Charlotte-Mecklenburg Historic Landmarks Commission

Historic Landmarks Department Staff Report – January 12, 2026

Landmark Name:	The Fidler House
Landmark Address:	21112 Catawba Avenue
City State Zip:	Cornelius, NC 28031
Applicant Name:	Jonathan Hutchinson
Item:	HLC527

The proposed project is a rear addition that would double the square footage of the building southward. The width of the footprint of the building will not increase. The increased footprint will require the removal of the existing garage/storage building located south of the subject building. The new addition will include increasing the conditioned space of both floors and adding a covered rear porch entry on the south elevation. The dimensions of the rear/south porch are approximately 6'-4" x 21'-0". The overall dimensions of the addition are approximately 34'-4" x 38'-10". The height of the addition will remain lower than the highest roof section of the existing. Proposed materials include unpainted brick foundation and lap siding to match the existing. All new windows and doors will be wood or aluminum clad wood with insulated glazing and molded muntins patterned to match existing. The scope of the addition wil

2 PROPOSED NE 3D VIEW
A1.2 NTS

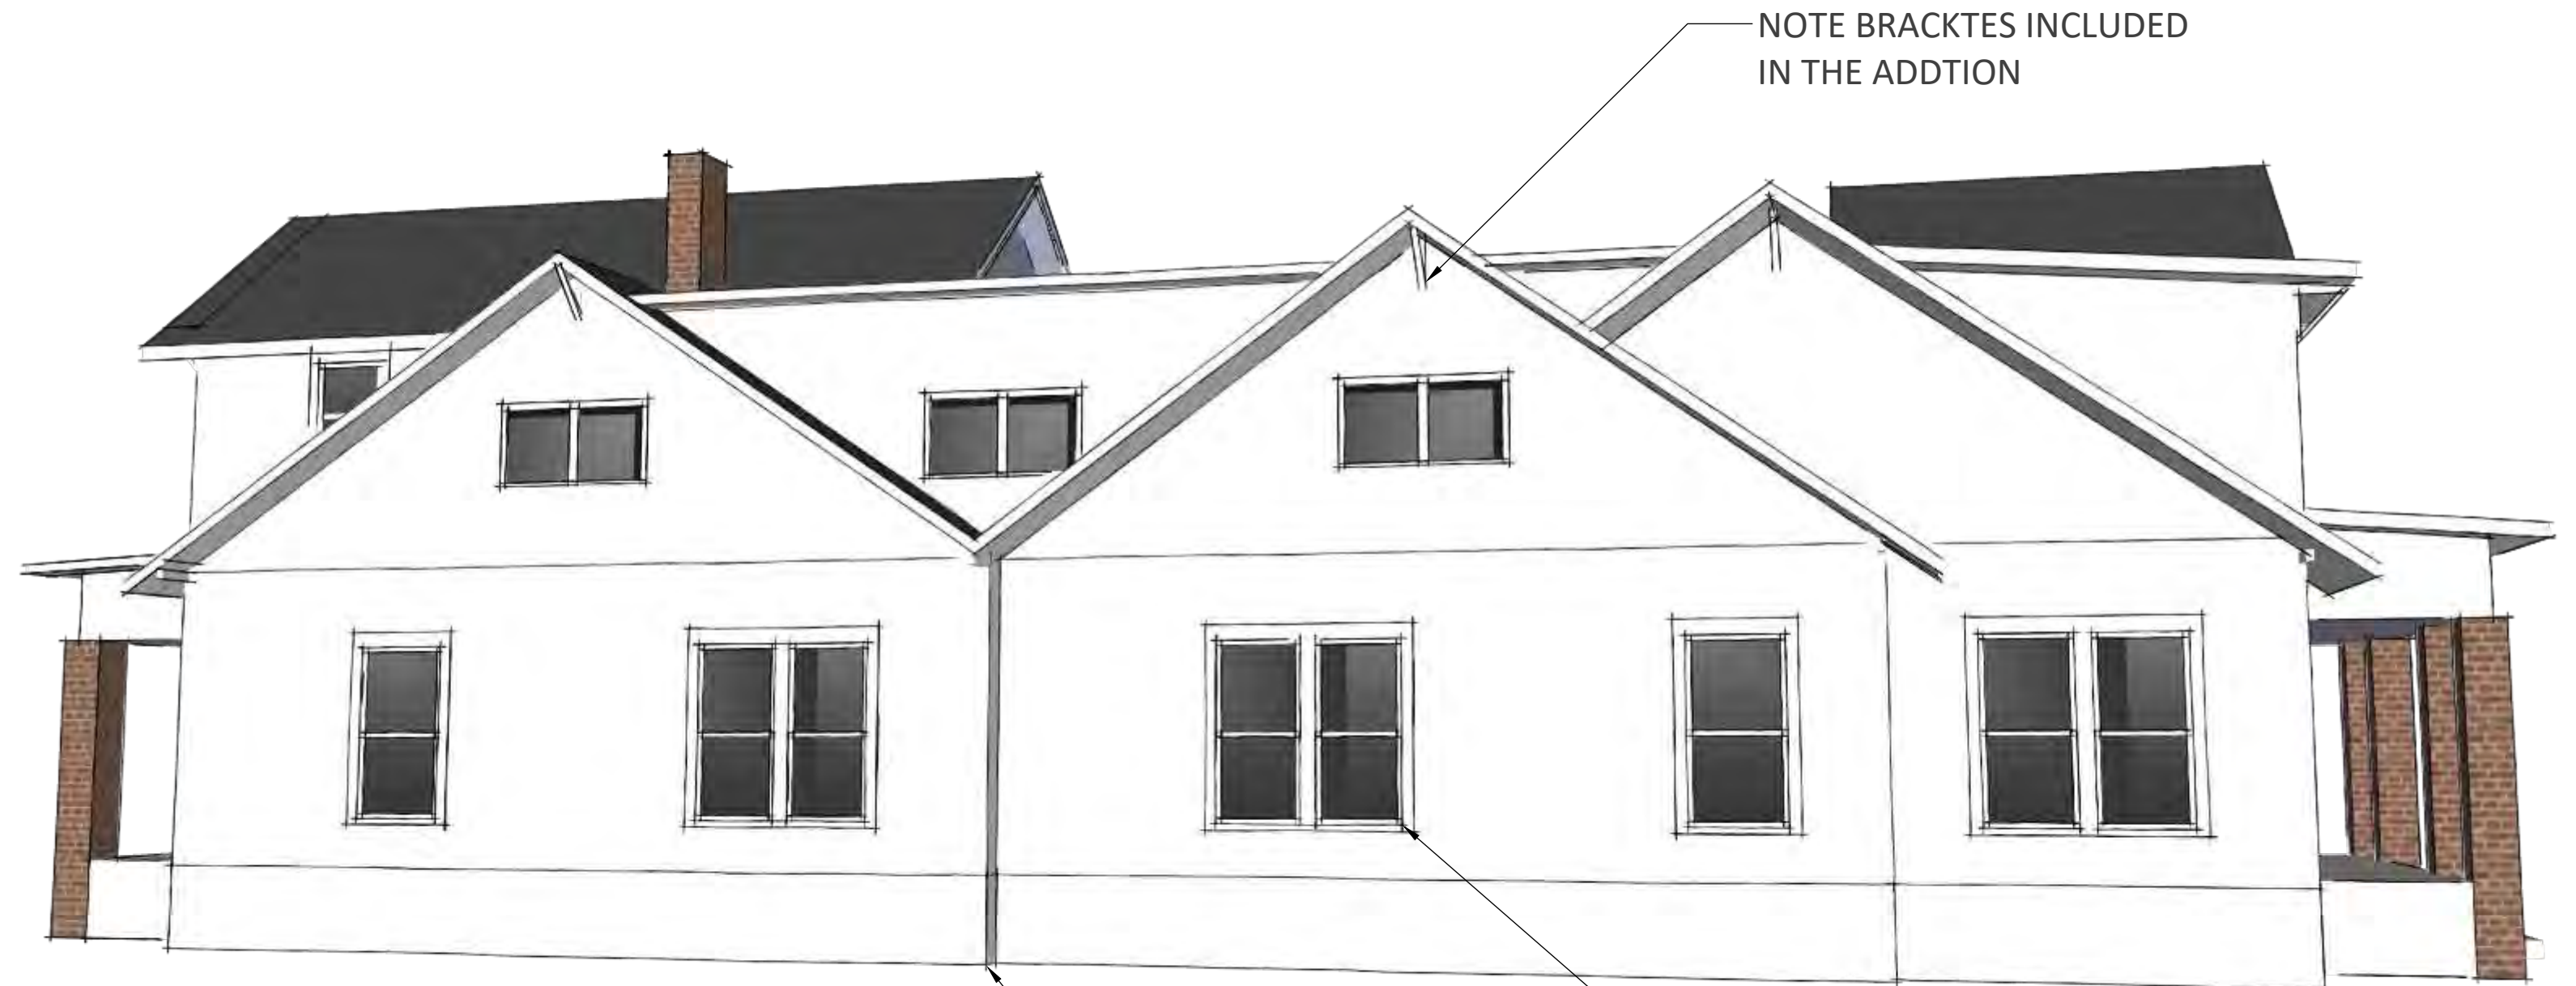
The proposal meets the Standards for height, width, and materials. However, the new addition directly behind the original building is coplanar and the rhythm of the side elevation is disrupted by the rear dormer over the porch. The twin side gable roofs and wall planes are flush with the original building making it difficult to differentiate new construction from the original side elevations.

3
A1.3
PROPOSED WEST 3D VIEW
NTS

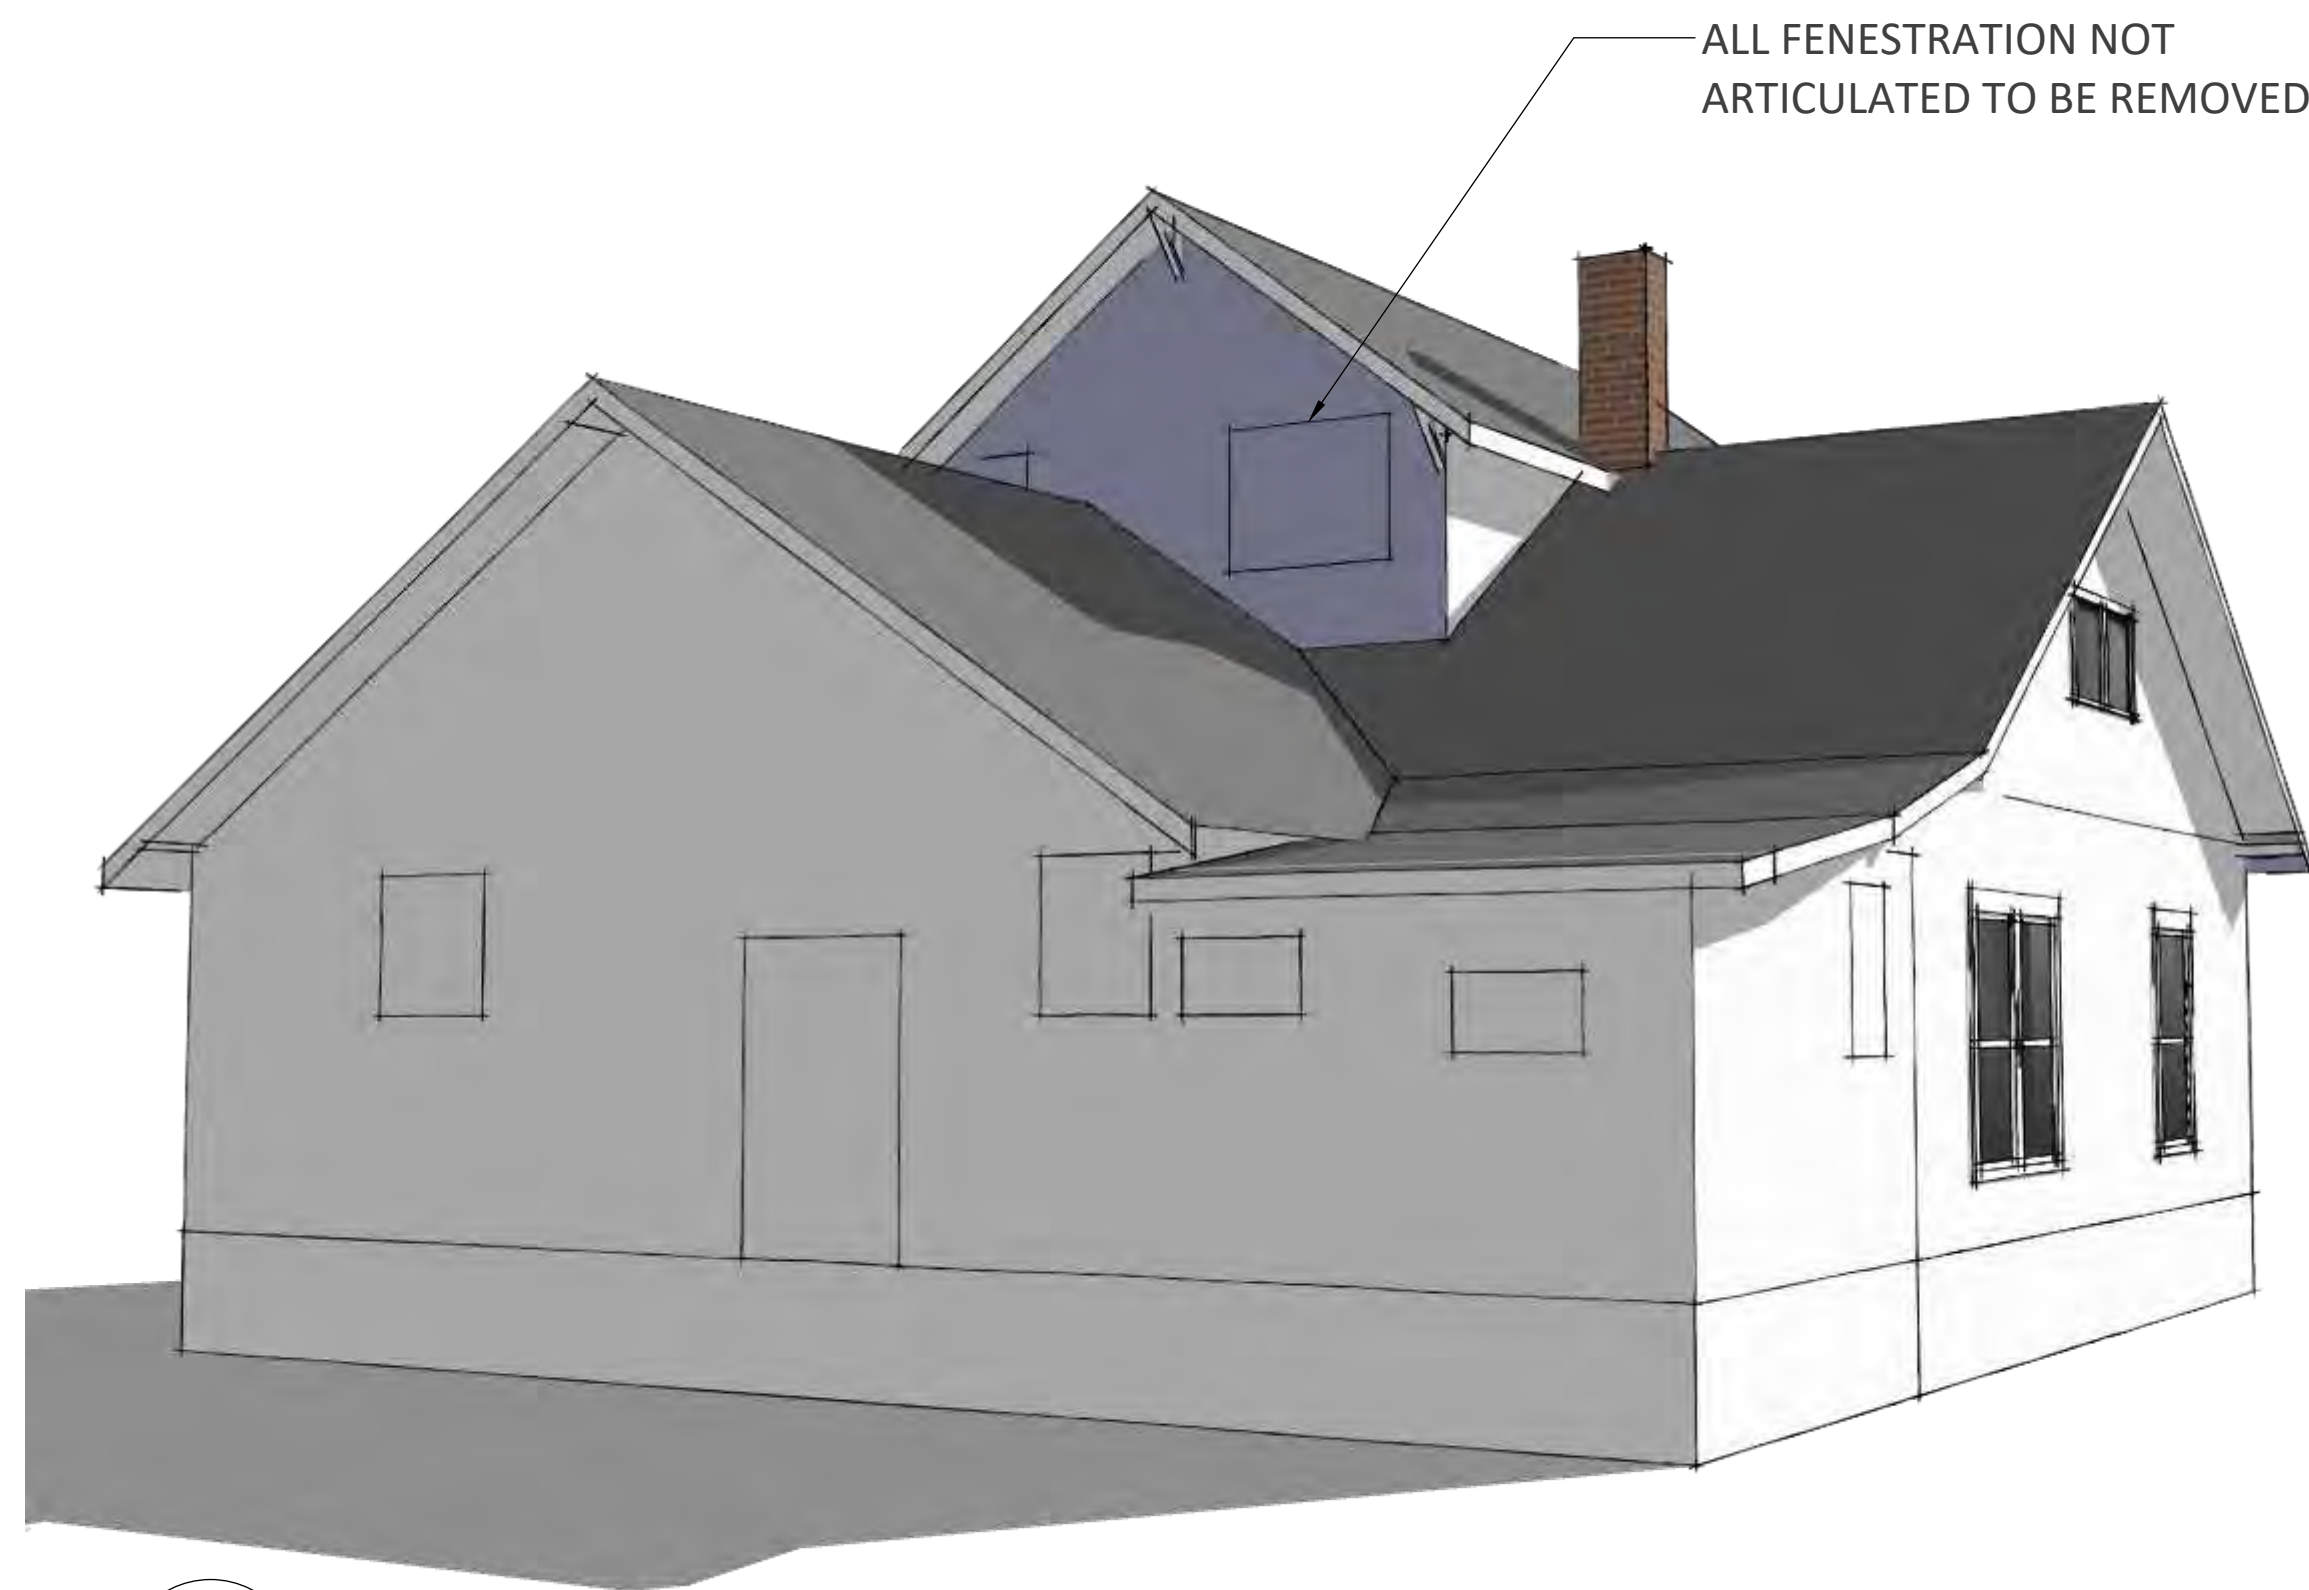
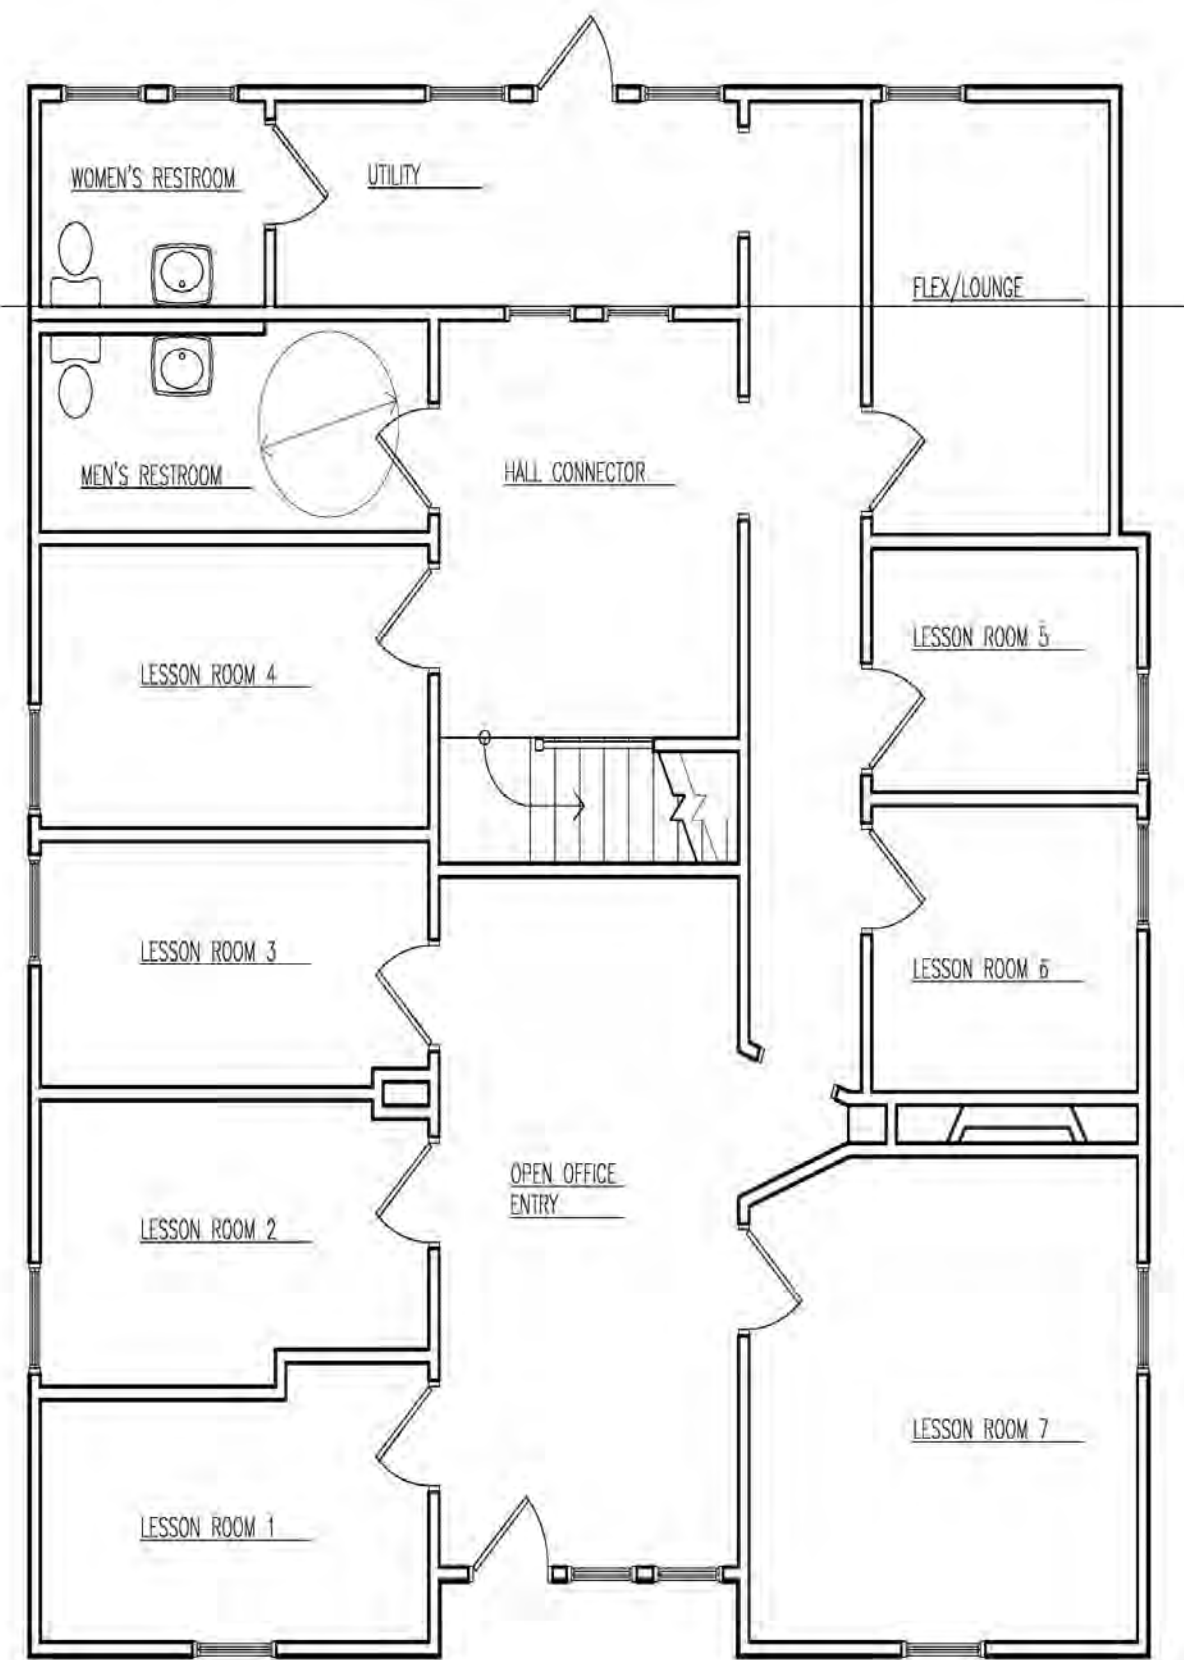
- 2.** The historic character of a property shall be retained and preserved. The removal of historic materials or alteration of features and spaces that characterize a property shall be avoided. **Character defining elements on the front and side elevations would not be altered (original windows, front dormer, eave brackets, materials). Rear dormer elevation windows would be removed.**
